CERTIFICATE OF APPROPRIATENESS

Property: 205 W. 16th Street, lots 47 & 48, and tract 46A, block 132, Houston Heights Subdivision.

Proposal: Alteration – Revise a previously approved COA to include altering the previously approved window trim.

WINDOW TRIM ALTERATION

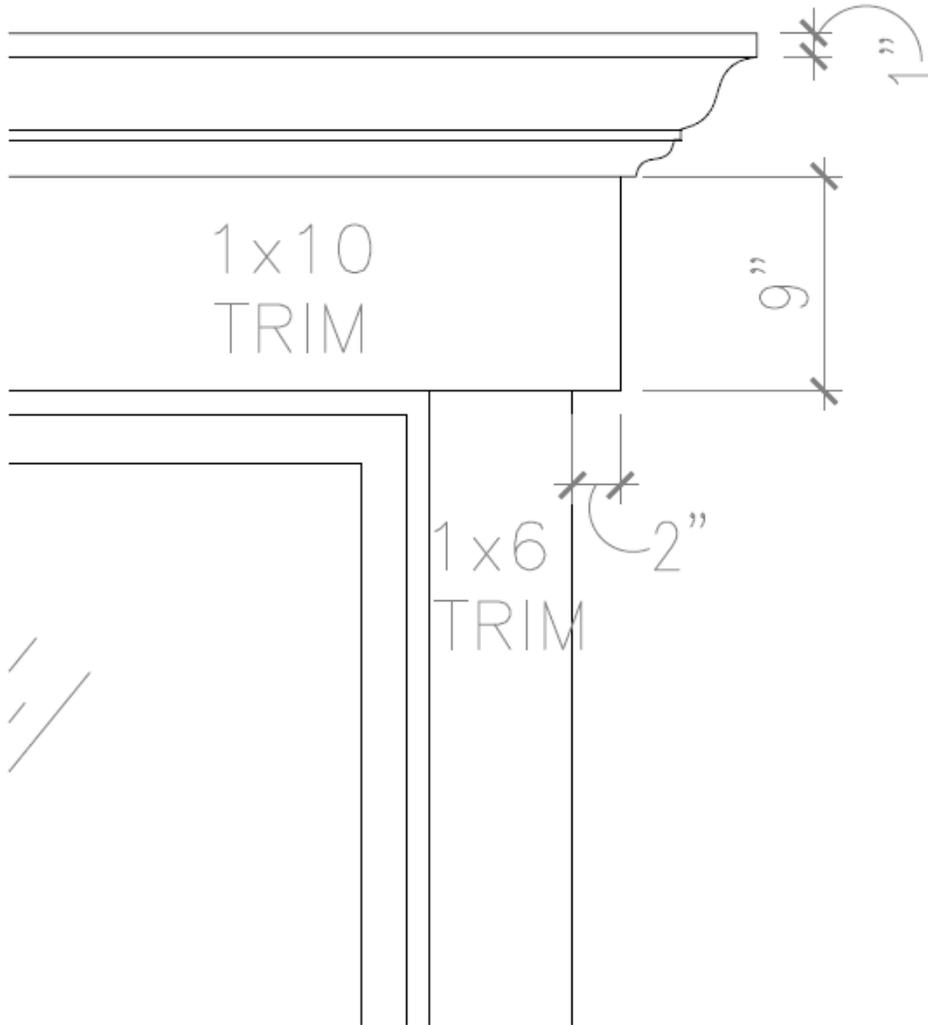
The proposed new residence received a Certificate of Appropriateness in November 2013. This application is a request to make revisions to the previously approved project. The applicant proposes to add approximately 6” of decorative crown moulding above the existing trim board.

Exterior Materials: Install a more decorative style window trim to the tops of all the windows instead of the previously approved more simple trim design.

The previously approved trim was a 2 $\frac{3}{4}$ " crown moulding above 1"x10" trim board.

The proposed trim is to be a total of 6 $\frac{1}{4}$ " crown moulding (5 $\frac{1}{4}$ +1") above 1"x10" trim board.
